PLANNING, ZONING, & BUILDING DEPARTMENT
PZ&B Staff Combination Memorandum: Architectural Commission and Town Council

SUBJECT: ZON-24-0042 (ARC-24-0080) 141 ATLANTIC AVE

MEETING: DECEMBER 20, 2024 ARCOM
JANUARY 15, 2025 TC

The applicant has submitted plans, entitled "A One-Story Addition and Renovation For: The Sloane Residence" as prepared by Brasseur & Drobot Architects, P.A, dated December 3, 2024.

PREVIOUSLY PROPOSED FRONT AND SOUTH ELEVATION

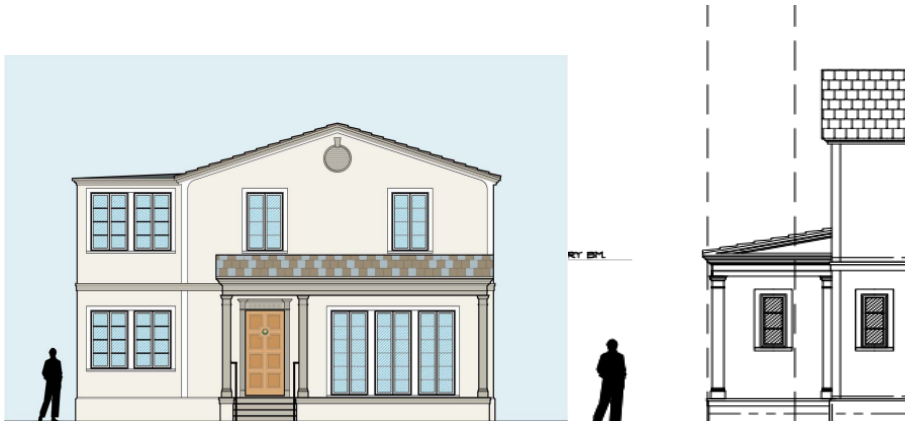
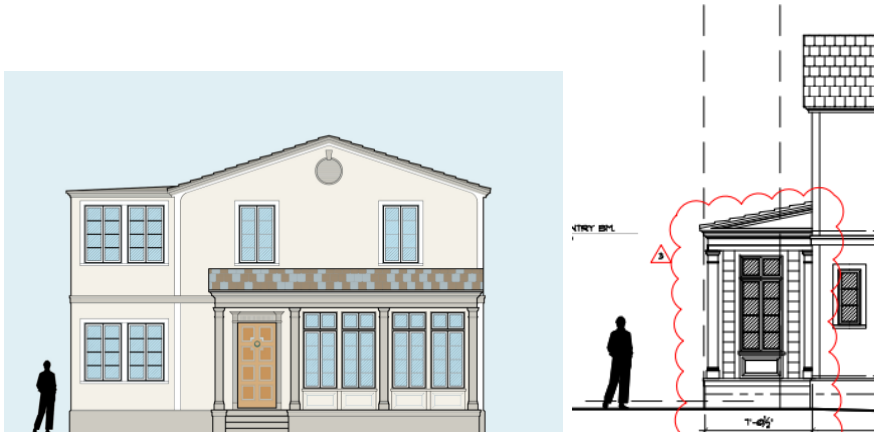
The application was first heard at the November 22, 2024 meeting. The item was deferred with a (7-0) vote with the direction to restudy the proposed first floor addition. The application is for the removal of an existing front porch of a single-family residence to allow for a first-floor expansion of approximately 110 SF. The addition will create additional living room space and present a new covered entry to the existing front door. Following the November deferral the applicant has revised the windows and transom configuration to include raised wood panels, and added a pilaster.

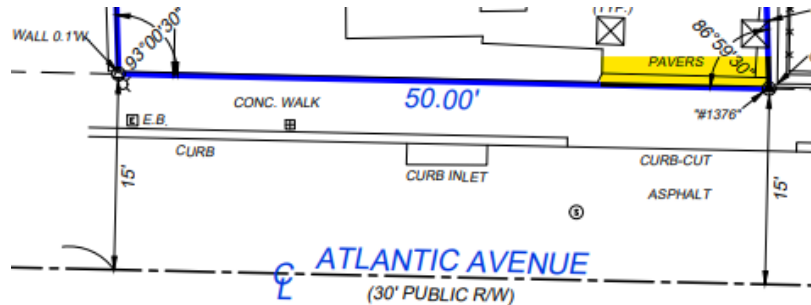
The current configuration of the driveway and front porch do not meet the minimum side setbacks, and the applicant proposes the new addition to align with the current building footprints east setback. The new construction will illicit one variance to align with existing nonconformity of the property, as the current structure is within the required setbacks. The proposed new addition will be setback 10.7' from the east side property line and span for 7'-0" in length.

Code Section	Permitted	Proposed	Variance
Variance 1: Sec. 134-893(b)(7) .	Min side yard setback of 12.5'	East Side Yard Setback 10.7'	+1.8'
